Project	Wrexham Glyndŵr University
Location	Site 2: Regent Street Campus
Title	Highways Addendum
Date	7 th December 2018
Author(s)	Mark Lever
Project Code	2627
Version	2

- 1.1 The following Highways Addendum has been produced to respond to a number of outstanding queries raised by Wrexham County Borough Council (WCBC) highways officers following submission of the relevant planning application (P/2018/0668) and a subsequent meeting on 12th September 2018.

Figure 4-1: On-street parking restrictions summary

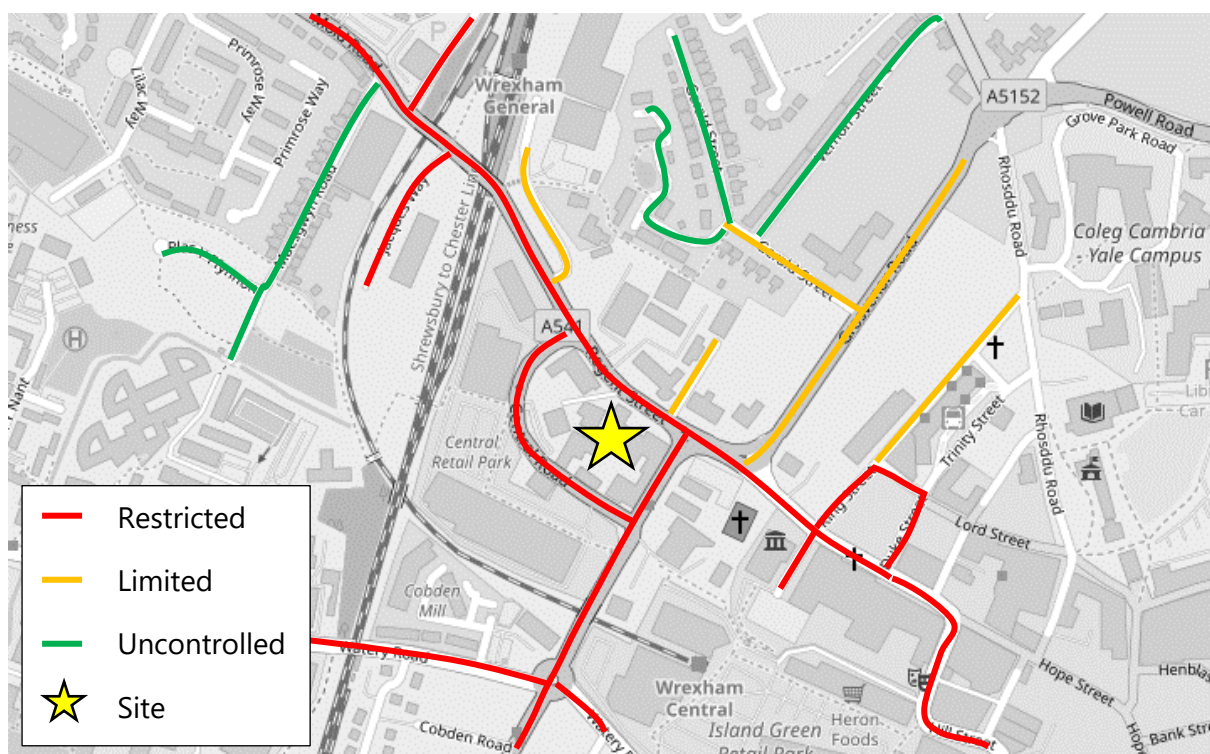
- 4.1 Figure 4-1 shows a summary of nearby on-street parking restrictions, with the implication being that the majority of surrounding streets are already subject to extensive parking restrictions or limited waiting periods and therefore will not be subject to overspill parking pressures.
- 4.2 Students will foremost be strongly discouraged from bringing a car with them to university, with provisions written into their lease agreement. In exceptional circumstances, such as when a student requires a car as part of their studies, they will be able park at the main Plas Coch Campus.

- 4.3 The distance between the site and the nearest uncontrolled on-street parking means that there is little advantage over parking at the main Plas Coch Campus. This becomes even less attractive when considering existing on-street parking is likely to be heavily utilised by existing residents and therefore finding a space will not be guaranteed.
- 4.4 Parking for students with disabilities will be provided on-site and therefore will not be required to park off-site or on the surrounding highway network.

DRAWING TITLE			
Proposed Loading Area			
BASE SCALE			DATE
1:250 @ A3			Oct 2018
DRAWING NUMBER			REV
DWG/2627/201			B

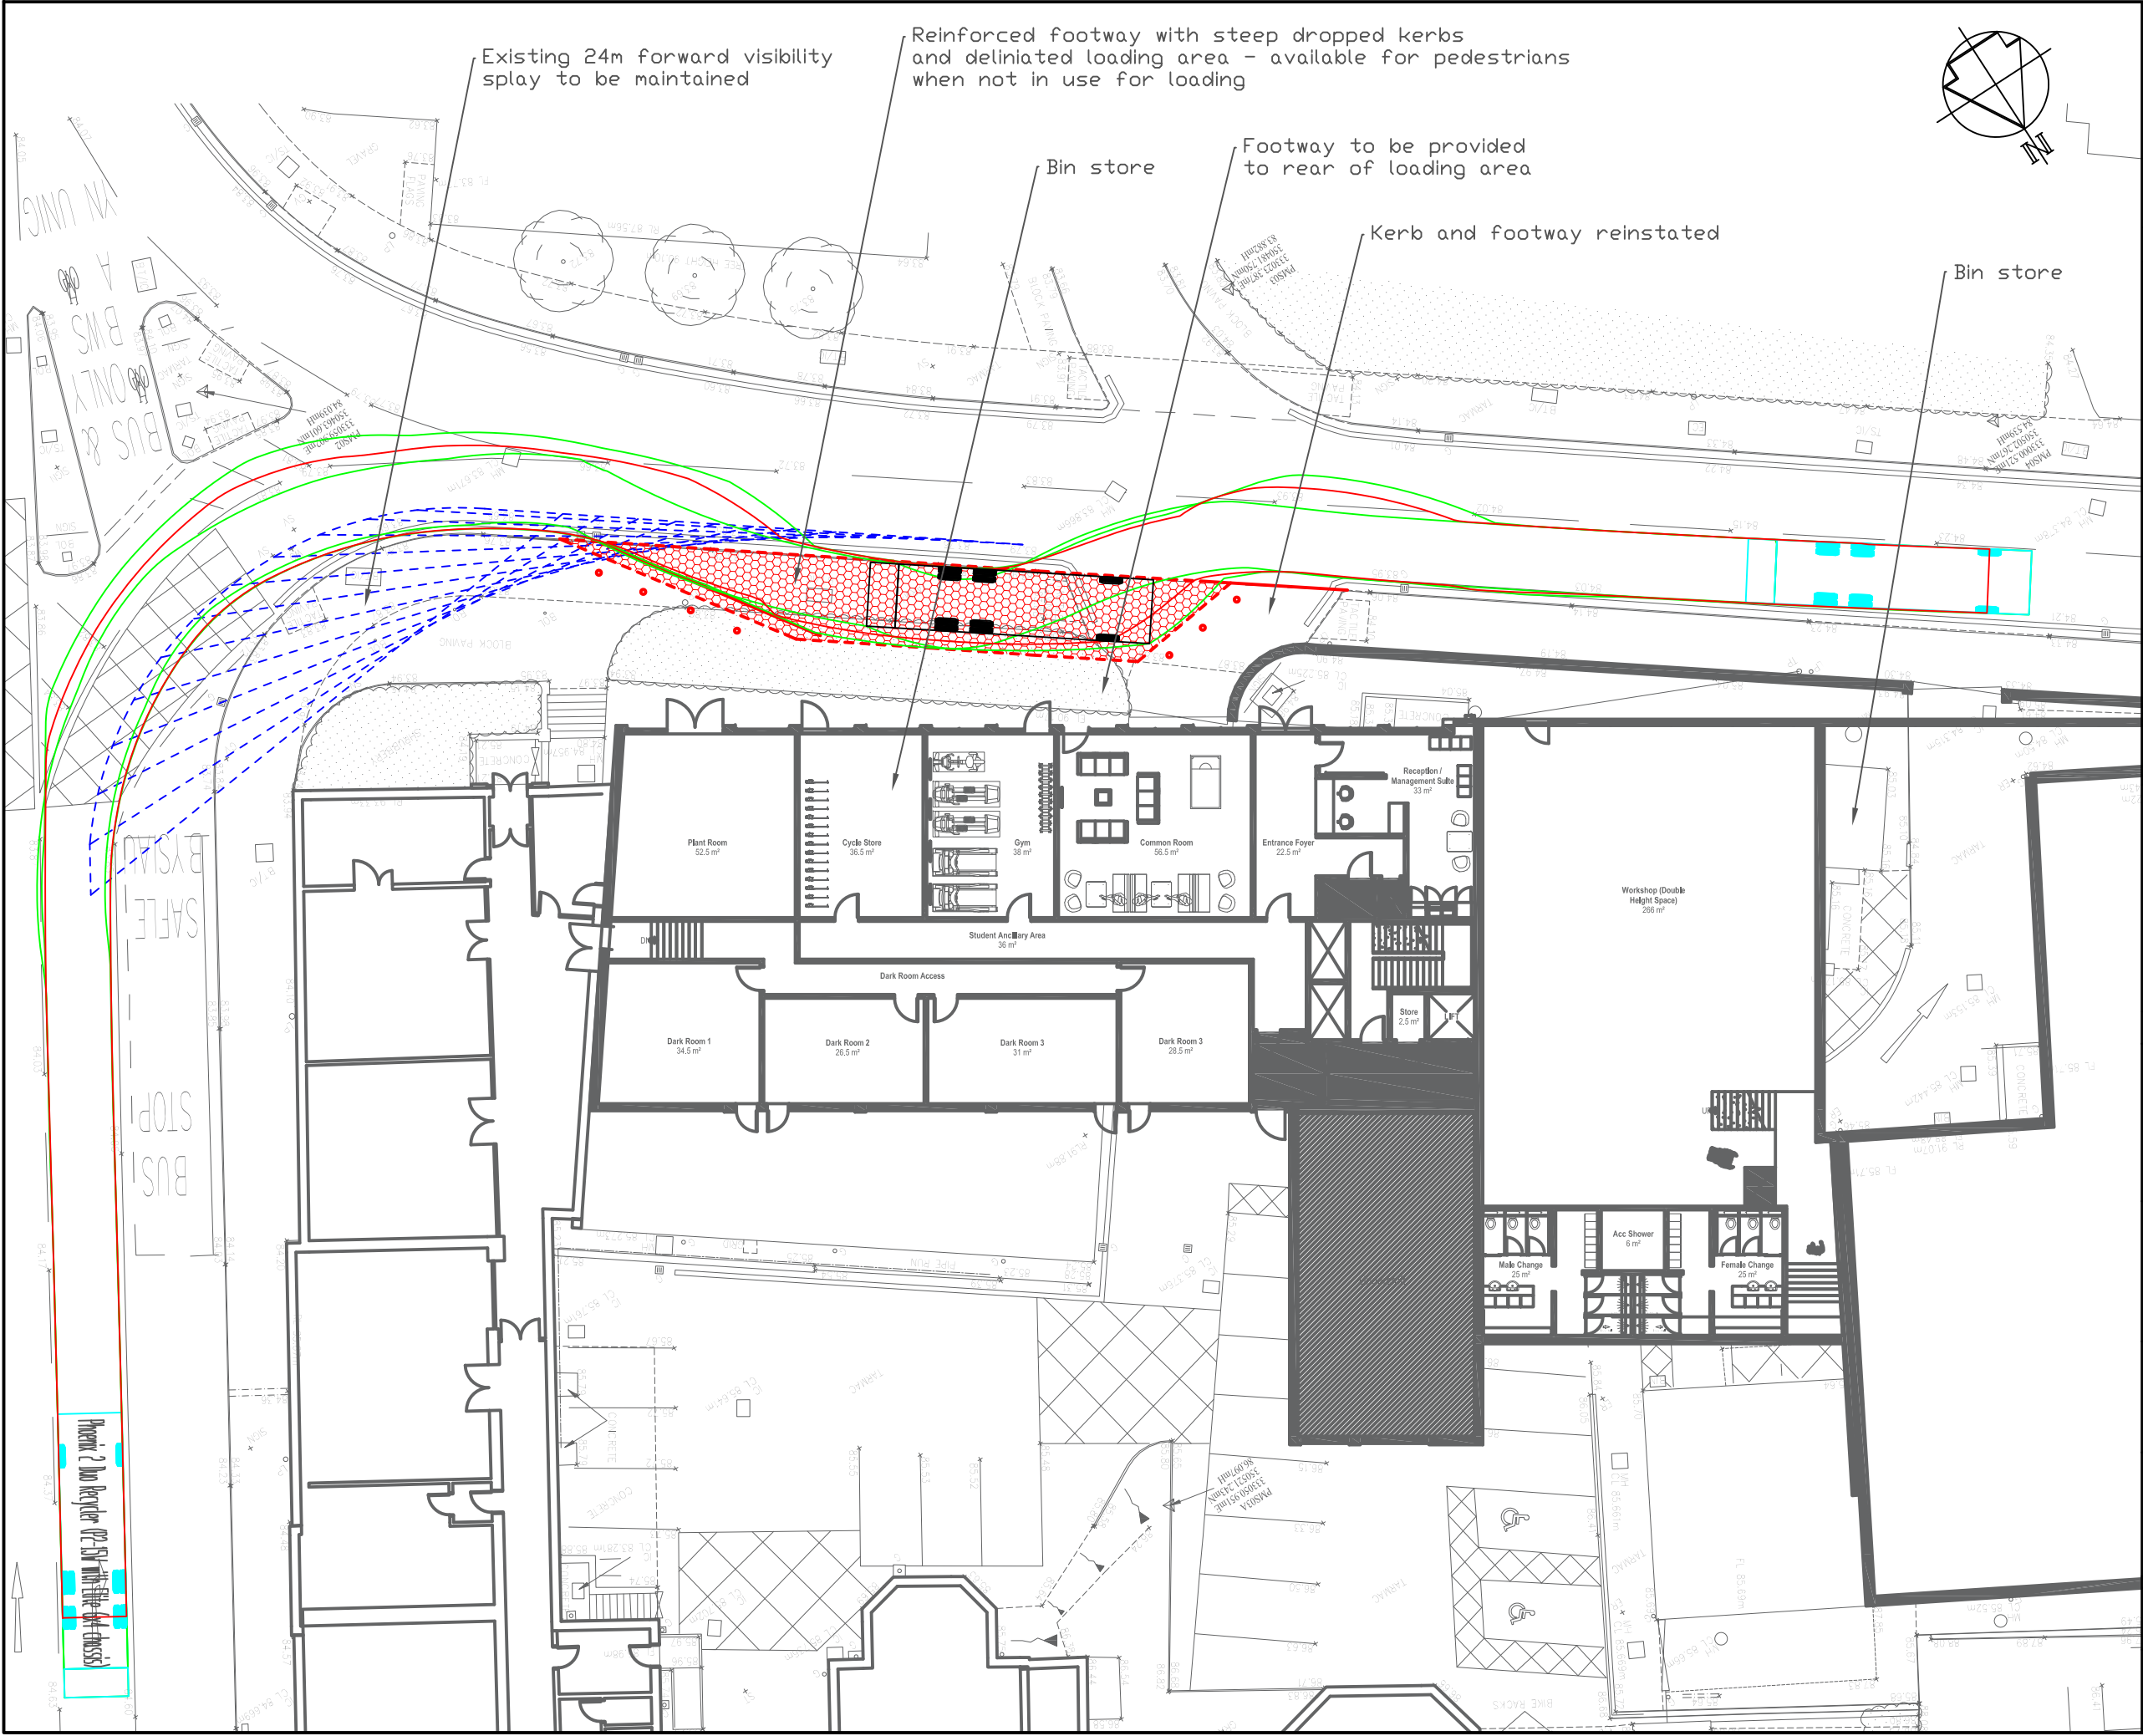
- 2.1 An updated layout plan, as seen in Figure 4-1, shows a revised position of the proposed loading area, considering previous comments by WCBC. Annotations on the drawing have also been added to show that the existing 24m forward visibility around

the corner from Bradley Road onto Central Road has been maintained and will not be interrupted when a refuse vehicle is parking in the bay.

- 2.2 Swept path analysis has been updated for an 11.2-metre-long refuse vehicle, as requested by WCBC.

- 2.3 The location of the loading bay has been clearly delineated and it is suggested that bollards or similar tactile obstacles be placed at either end of the area, both to prevent vehicles overrunning onto the footway and to guide pedestrians with visual impairments safely around the area. This, however, will be subject to detailed design and agreement with WCBC at a later stage.
